UNITED STATES PATENT AND TRADEMARK OFFICE

Office Action Summary

10/824,827

DETAILED ACTION

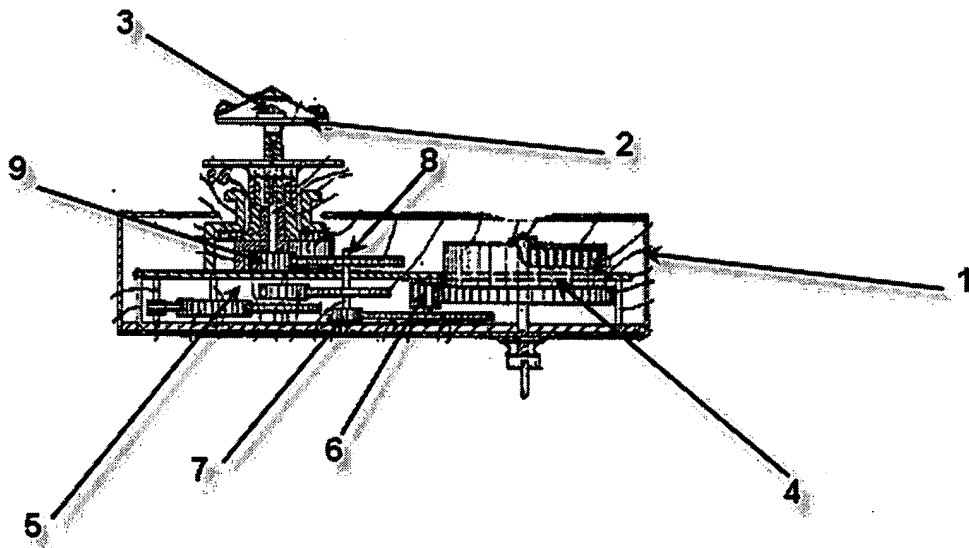
[7] Claim 11 is rejected under 35 U.S.C. 102(b) as clearly anticipated by Blume, US-1,025,447, because the invention was patented or described in a printed publication in this or a foreign country, or in public use or on sale in this country more than one (1) year prior to the application for patent in the United States.

The shape and appearance of Blume is identical in all material respects to that of the claimed design, *Hupp v. Siroflex of America Inc.*, 122 F.3d 1456, 43 USPQ2d 1887 (Fed. Cir. 1997).

As for Claim 11, Blume teaches of a jewelry item with a rotating gemstone (see figure below) comprising:

a substantially hollow housing (1) having an upper end and a lower end;

a bezel (2) rotatably mounted on the upper end of said housing;

a gemstone (3) mounted on said bezel (2);

a motor means (4) received within said housing (1) for automatically rotating said bezel and said gemstone (3) at a predetermined, discrete speed (after the winding of the spring, the motor then actuates the gears at a predetermined, discrete speed);

a gear assembly (5) including a plurality of gears (6-9) driven by said motor means (4) and operably connected to said bezel (2), said gears (6-9) having a predetermined, precise gear ratio for rotating said bezel at a discrete speed, wherein said gear assembly (5) further includes a drive gear (6) connected to said means (4); and an intermediate gear (7) engaging said drive gear (6), said intermediate gear (7) having an upper surface with a sprocket (8) extending therefrom, and a bezel gear (9) connected to said bezel (2) and engaging said sprocket (8).
